Ref: FCC Class II Permissive change for FCC ID: 2AIF-10847PG

This is to request a Class II Permissive change for FCC ID: 2AIF-10847PG originally granted on 03/18/2024.

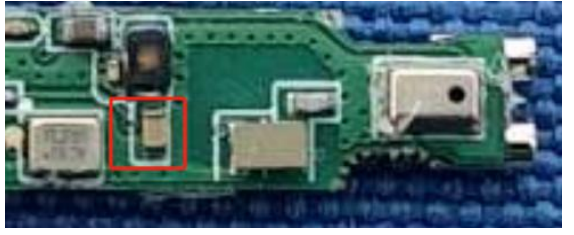
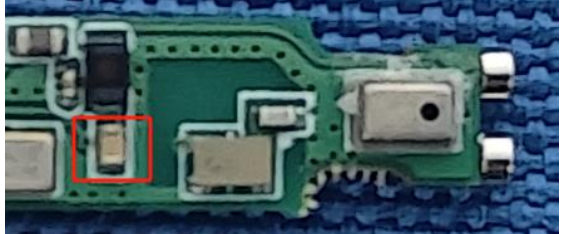
The change under this application is Based on the original model 10847PG, 10925PG, 10926PG, additional one series models 11869PG have been added. The color of appearance and model name of series models listed are different from the main model, but the circuit and the electronic construction are the same, The model 10847PG, 10925PG, 10926PG Pro and 11869PG only changed the supplier of the capacitor C9 of on the substrate.

Supplier	specification	Photos
Original	Superior Communications DBA PureGear	106/10V 0402 $\pm 10\%$	
New	ShenZhen Kingvie Technology Co., Ltd	106/10V 0402 $\pm 10\%$

The changes are not related with the other RF parameters, only "Conducted Emission and Radiation Spurious Emission of below 1G" were retested, other data were referred to the original report
